FIRE RATED FEC

02/21/12 ISSUED FOR BIDS 1 03/15/12 ADDENDUM #3 . . . . . . . . . . . . .

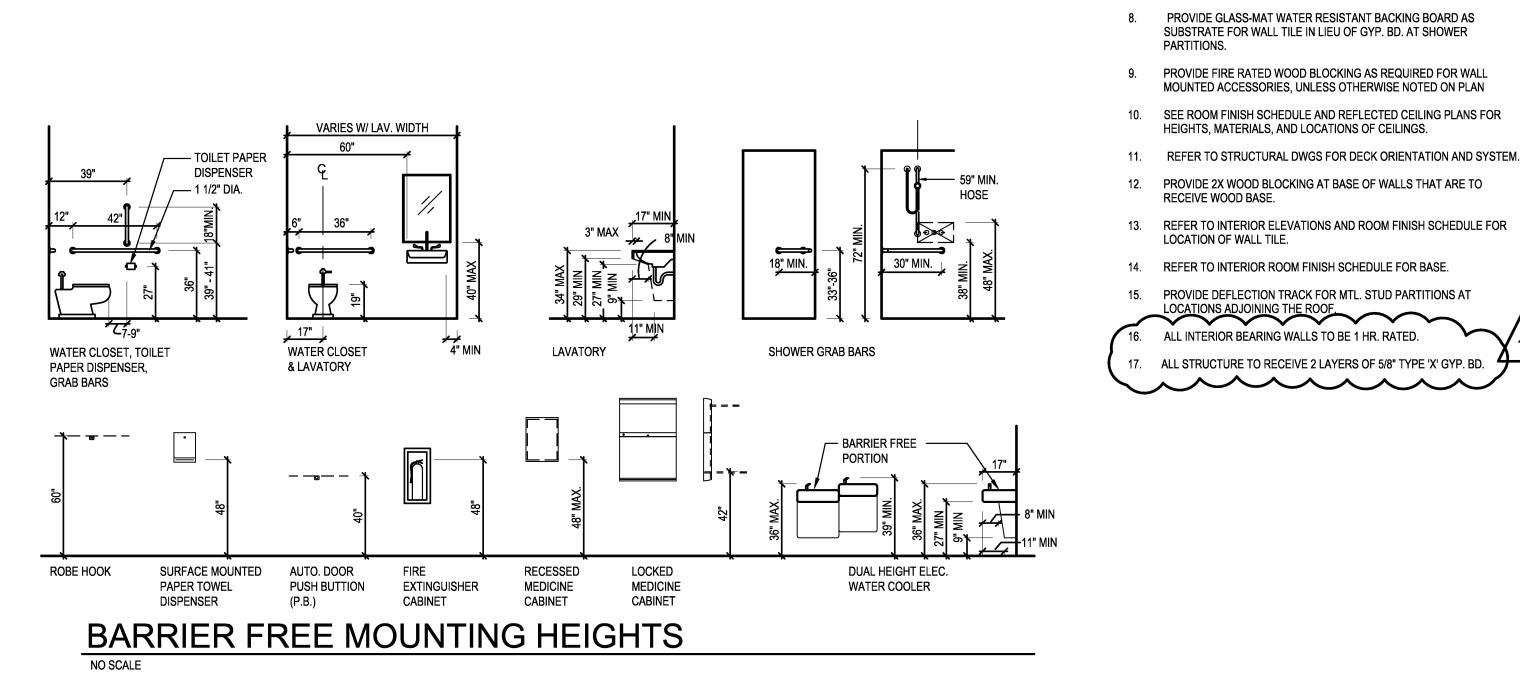
ADD 5/8" GYP. BD. ON FIRE

TO FLOOR PLAN AND PARTITION TYPES.

RATED PARTITION - REFER
